Subject: FW: DC/25/99887 32A QUEENS VIEW, NETLEY ABBEY - Discharge of Conditions - landscape comments

I have reviewed the latest revised landscape plan for this site.

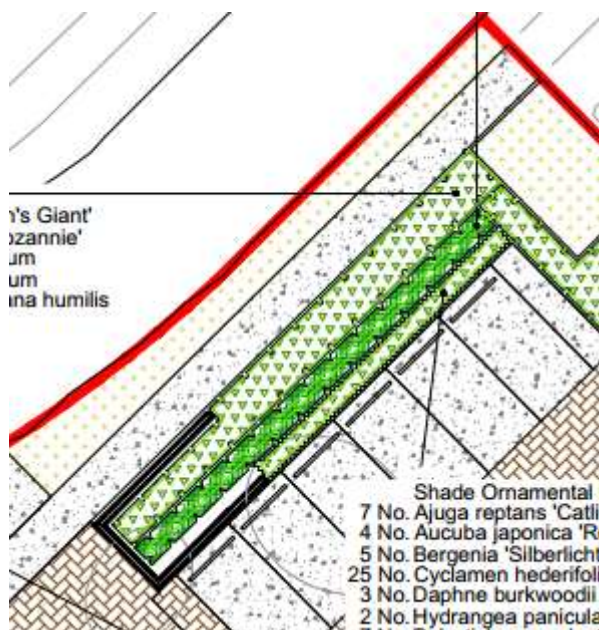
There is only one point that I would like the applicant to consider. Since Highways have said no trees can be planted along the frontage here:

Can they please add 3 no. multi-stemmed shrubs (*Amelanchier lamarckii*) in front of the hedge (roadside) to provide at least some slightly higher softening long-term of the parking area in views from the road.
